FCC CLASS II PERMISSIVE CHANGE REQUEST LETTER

RE: FCC Permissive II Change Request for Company : Sasse Elektronik GmbH FCC ID : UXA-990516X

- Transceiver Module TM2.4-1 Model-No. 1350.9905162
- Transceiver Module TM2.4-2 Model-No. 1350.9905161

Figure 1: Block diagram

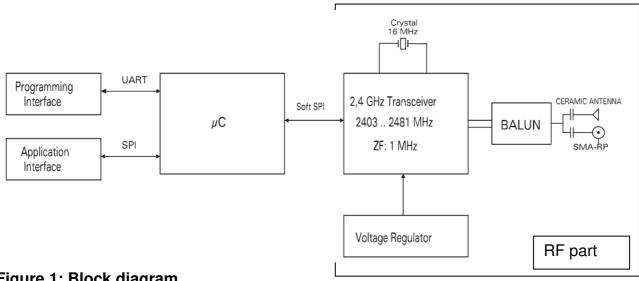
The current 8-bit microcontroller of type NXP 89LPC932 has become obsolete.

This microcontroller has been replaced by type:

STM32L051K6 from ST Microelectronics

The RF part of the transceiver module has not been changed (no changes in PCB layout and components of the RF part).
